DIABLO CANYON INDEPENDENT SPENT FUEL STORAGE INSTALLATION SAFETY EVALUATION REPORT

**U.S. Nuclear Regulatory Commission
Contract No. NRC-02-02-012**

**Center for Nuclear Waste Regulatory Analyses
San Antonio, Texas**

October 2003

Figure 2-1. Potential failure modes of the subsurface material under the cask-storage pad when subjected to the design-basis seismic ground motion. Both failure modes were considered in the applicant evaluation of the seismic stability of the pad.

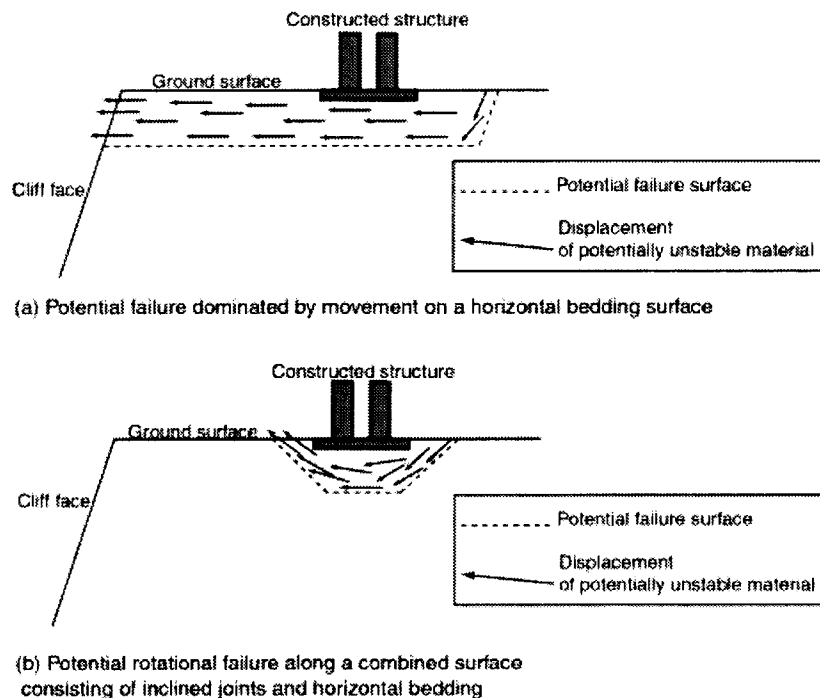
applicant⁴ to respond to staff requests. The evaluation considered the two failure modes illustrated in Figure 2-1. These potential failure modes needed to be considered because of the occurrence of near-horizontal clay beds that are significantly weaker than the surrounding rocks. The occurrence of the clay beds does not constitute a problem under static-loading states, because the static load is applied vertically and, as a result, would not cause any significant shear stress in any of the clay beds. Dynamic loading from the design-basis seismic ground motion, however, has horizontal and vertical components. The clay beds within the subsurface materials under the storage pad would, therefore, be subjected to shear stresses during an earthquake. The shear stress in the clay beds may result in a bearing-capacity failure of the storage pad following one of the two failure modes illustrated in Figure 2-1.

The applicant analysis for the horizontal-sliding failure mode [Figure 2-1(a)] is documented in PG&E Calculation GEO.DCPP.03.01, Revision 0, "Determination of Earthquake-Induced Displacements of Potential Sliding Mass Beneath DCPD ISFSI Site." The analysis considered the stability of an approximately rectangular block of rock 155.4 m [510 ft] long, 149.4 m [490 ft] wide, and 15.2 m [50 ft] thick. The top of the block includes seven ISFSI pads carrying 20 fully loaded storage casks each, and the base surface of the block is assumed to pass through a thin but continuous clay bed. The dimensions of the block were determined based on the geometry of the ISFSI pad, the canyon wall to the north of the pad, and the clay beds. The driving force considered in the analysis consists of a static representation of the lateral earthquake force calculated as αW , where W is the total weight of the block and, $\alpha = 0.43$, which is about half of the PGA for the design-basis ground motion. This evaluation of the driving force is consistent with standard practice (e.g., Kramer, 1996, p. 436). Resistance to sliding was considered as arising from the shear resistance of the clay bed at the base of the block and the shear resistance of the rock-mass on the vertical boundary surface of the block, except the canyon face. The shear resistance parameters used in the analysis are consistent with the information reviewed previously under "Geotechnical Site Characterization."

A factor of safety of 1.02 against horizontal sliding [similar to the failure mode illustrated in Figure 2-1(a)] was obtained through the analysis. This factor of safety indicates that a potential horizontal sliding of the ISFSI foundation during a design-basis earthquake cannot be ruled out based on the analysis provided by the applicant. The applicant performed an evaluation of the potential sliding displacement using the Newmark (1965) sliding-block approach. The analysis indicates that the foundation may experience a sliding displacement [Figure 2-1(a)] on the order of a few inches {approximately 1.0 cm [2.5 in]} during a design-basis earthquake. Staff concludes that such horizontal displacement would not have any significant impact on any safety function of either the pads or the storage casks.

The applicant analysis for the rotational failure mode [Figure 2-1(b)] is documented in a PG&E Calculation, "Evaluation of Potential Rotational Failure of Foundation Beneath DCPD ISFSI

Pads in Attachment 2-2.”⁵ The analysis consists of evaluating the allowable bearing pressure for the pad and comparing it against the bearing pressure that may be imposed on the pad during a design-basis earthquake. The allowable bearing pressure for a shallow foundation such as the storage pad is equal to the ultimate bearing capacity, such as, the value of foundation pressure that would cause a rotational failure [e.g., Figure 2-1(b)], divided by a safety factor.
